**Antler Energy LLC  
Klaenhammer 1  
Location #312861**

**Missing information**

**North entrance to location**

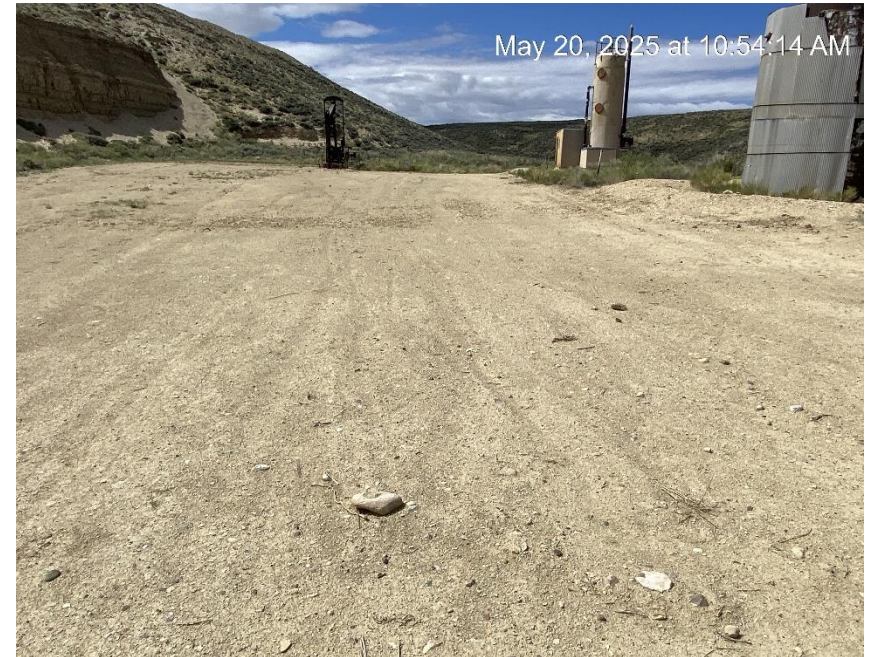
**300 x 150% = 450 bbl berm required**

**20' x 26' – 18" = 140 bbl berm capacity**
